**PUBLIC USE SPACE AND AMENITIES PLAN**  
**RIPLEY STREET**  
 Wheaton Election District #13  
 Montgomery County, Maryland  
 July 8, 2004

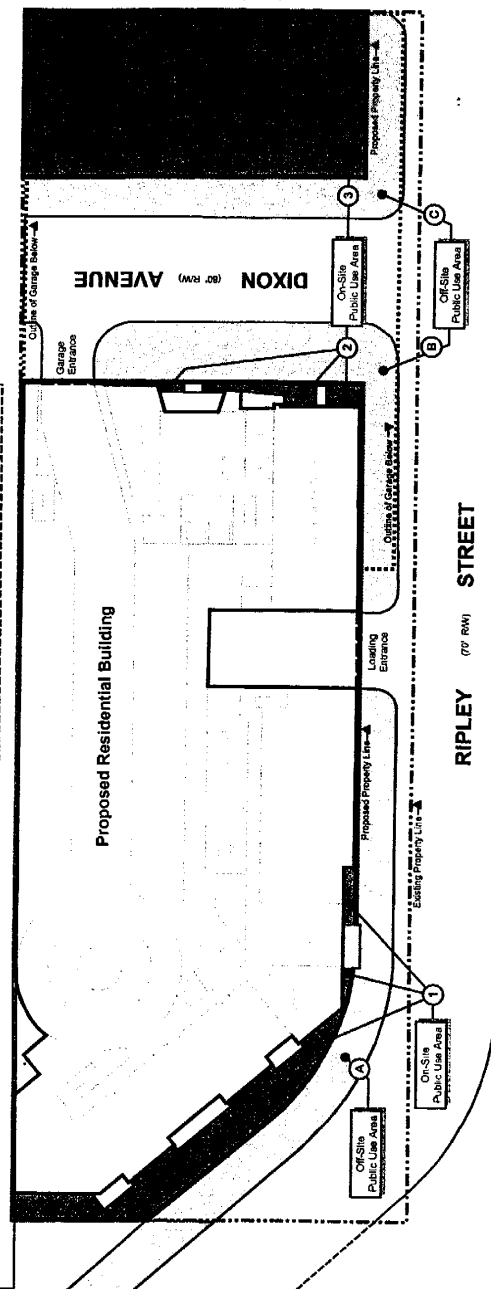
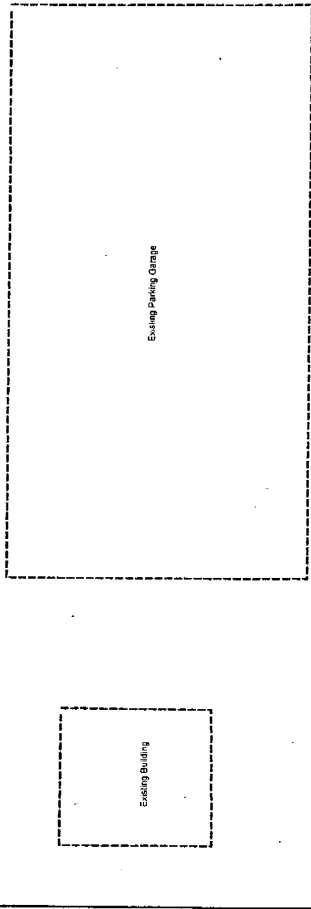
- B. **Sector Plan Bikeways:** The Sector Plan recommends a Class 1 bikeway (off-road) for Dixon Avenue. Staff recommends that at the time of Preliminary Plan review, the applicant provide a Class 1 bikeway on the West side of Dixon Avenue from Ripley Street through Public Garage #5 to Bonifant Street.

- C. **Sector Plan Street Rights-of-Way:** The Sector Plan recommends the street right-of-way for Ripley Street as 70 feet. Staff recommends that the applicant, at the time of Preliminary Plan review, dedicate additional street right-of-way and construct the street improvements on the north side of Ripley Street equal to 35 feet measured from the centerline of the existing street. The Sector Plan also illustrates a conceptual alignment of Ripley Street connecting to Bonifant Street through a portion of the future Transit Center project. The Ripley Street to Bonifant Street connection will provide additional street connectivity from the CBD core to the Ripley District.

The Sector Plan recommends an 80-foot street right-of-way for Dixon Avenue from Wayne Avenue to Silver Spring Avenue. Dixon Avenue will provide additional street connectivity from the CBD core into the Ripley District. The public parking (Garage 5) located to the north of the proposed development is designed to allow for the extension of Dixon Avenue through it. The applicant has coordinated with DPWT regarding improvements to the garage such as opening the southern end and some aesthetic improvements. Staff recommends that the applicant, at the time of Preliminary Plan review, dedicate 80 feet of street right-of-way and construct the street improvements for Dixon Avenue from the face of Garage 5 to Ripley Street.

- D. **Streetscape:** The applicant proposes to improve Ripley Street and Dixon Avenue using the Type B treatment recommended in the *Silver Spring Streetscape* (April 1992) technical manual. The staff recommends that the applicant enter into an agreement with the Silver Spring Urban District for maintenance of all or some of the streetscape improvements.
